SECTION 4.55 (1A) MODIFICATION - SSD 6840

This Statement of Environmental Effects (SEE) has been prepared on behalf of St Vincent's Private Hospital (the Applicant) in support of a Section 4.55(1A) application to modify development consent SSD 6840.

By way of background, development consent was granted to SSD 6840 by the NSW Department of Planning, Industry and Environment (DPIE) on 17 September 2015 for the redevelopment of St Vincent's Private Hospital located at 406 Victoria Street, Darlinghurst (the site).

Figure 3 Approved Plans – SSD-6840

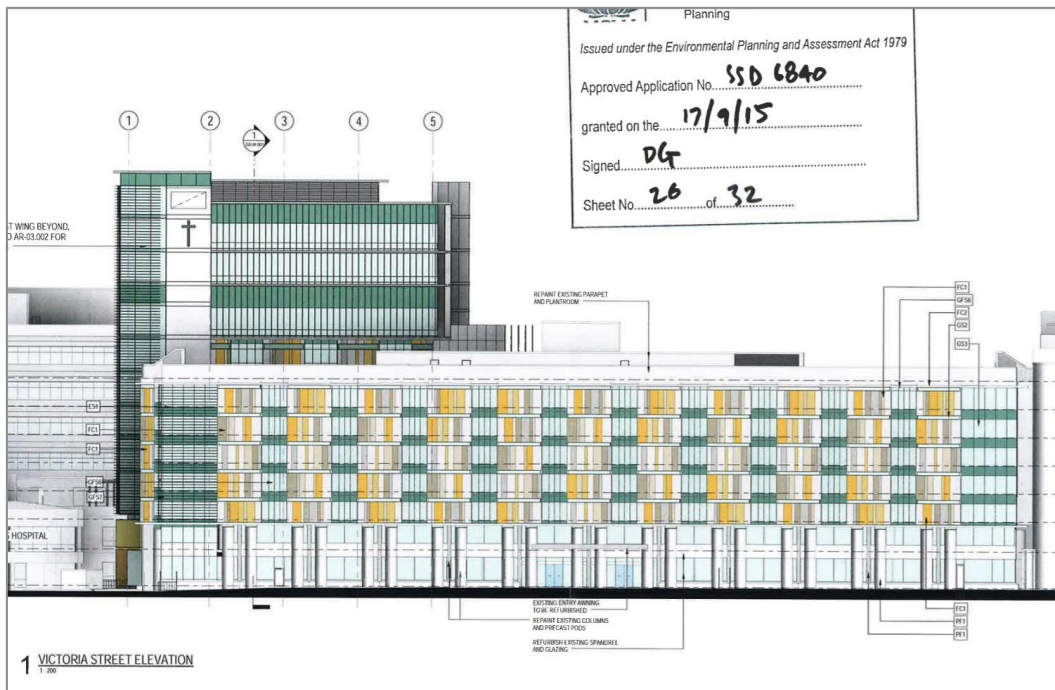
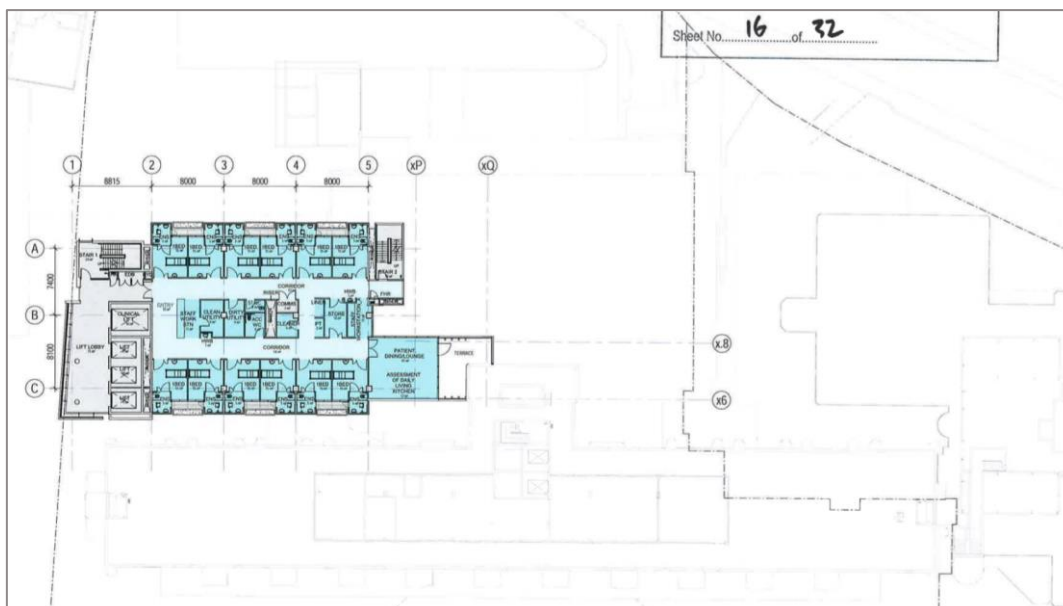
The architectural elevations prepared by Hassell and approved under SSD-6840 identified an existing parapet and plant room however did not provide specific details regarding the new rooftop plant proposed on Level 11.

Similarly, the approved Level 11 floor plan denoted broad areas of plant, predominantly relating to the existing plant, however, did not specify the type of plant, maximum RL's or what was located within the confines of the plant room (see Figure 3 on the following page).

This modification seeks to rectify this by submitting architectural plans and elevations which clearly denote details of the proposed mechanical roof plant on Level 11.

Figure 5 Approved and Proposed Northern Elevation

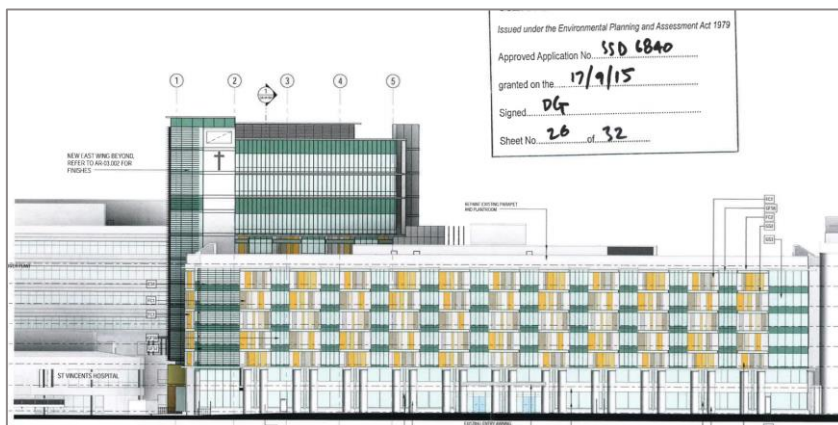
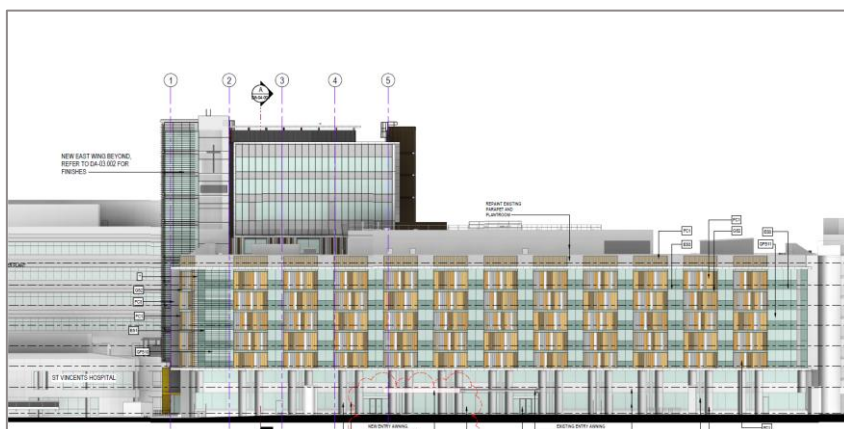
As discussed in Section 2, the previously approved plans did not clearly denote the proposed rooftop plant on Level 11. This modification seeks to rectify this and formally seek consent for a new rooftop plant on Level 11.

As evident in Figure 5, the rooftop plant has been carefully designed to ensure the plant level integrates with the overall building composition. The plant does not exceed beyond the highest point of the existing high rise building and will sit below the lift overrun.

The inclusion of the new plant is essential to ensuring the building services are reliable and up to date. It is critical in providing the care environment needed on both the operating and the Inpatient Unit floors within the hospital and will bring the building up to the relevant health codes.

- **Clause 2.2 - Zoning** – The site is zoned SP2 Infrastructure. The proposal does not seek to amend the approved land uses.
- **Clause 4.3 – Building Height** – The site is not subject to a maximum building height. The proposed roof plant will have a maximum RL height of RL 74.780.
